White Paper

TANBREEZ Project

A short description of the white paper for the TANBREEZ Project - the content and its purpose

Photo of fluorspar, the grain is 1 mm in size.

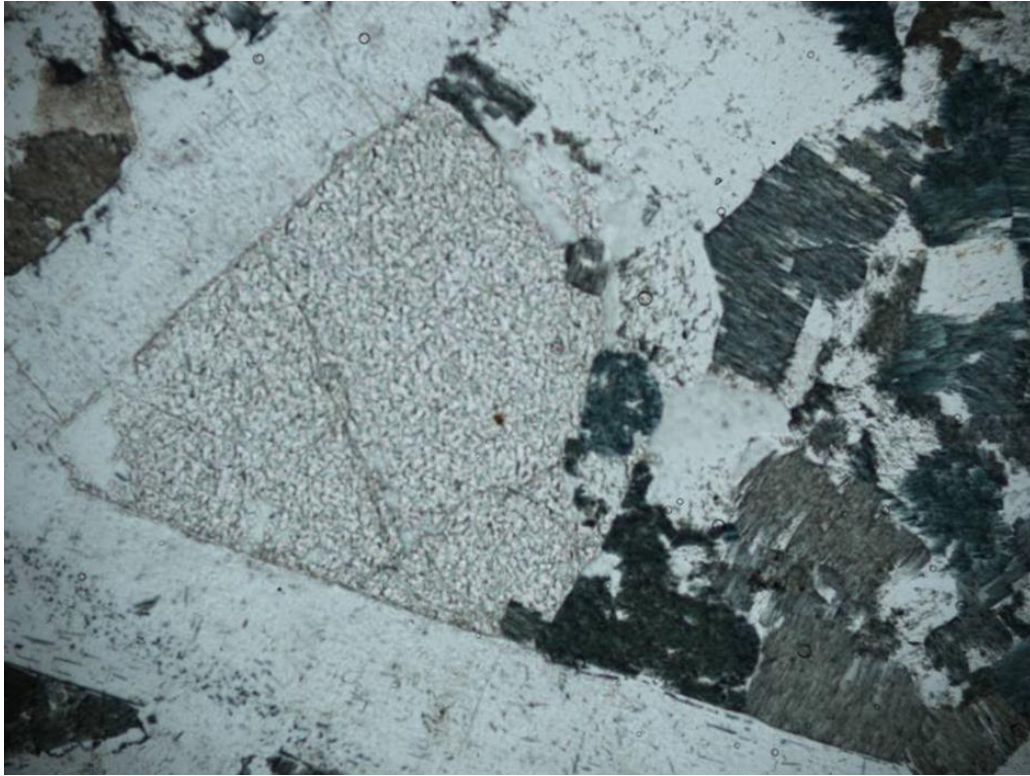
No.	Question/comments	TANBREEZ' answer	Comments from authorities	Changes to EIA
		The sample No 154335 quoted occurs within a black kakortokite was still in the archives of GEUS. This sample has been re-examined. This sample was taken from the surface contained none of the characteristic holes after villemite. Secondly, such surface samples nowhere in the complex contain fresh villemite on the surface (in fact villemite has never been anywhere in the world). Thirdly, slides taken of the rock and micro photographs clearly show fluorite grains (see photo below) here up to 1 mm in size. There is sufficient amount of fluorite in this sample to explain the fluorine assay in the original rock. Thus, there is no chance geologically, chemically or physically for any villemite to be in sample No 154335 and certainly it cannot contribute to any fluorine pollution to the water. To document that the ore contains no solvable fluorine TANBREEZ will test a number of samples in accordance with a protocol agreed with the DCE. The results will be included in the final EIA report. <u>Literature</u>
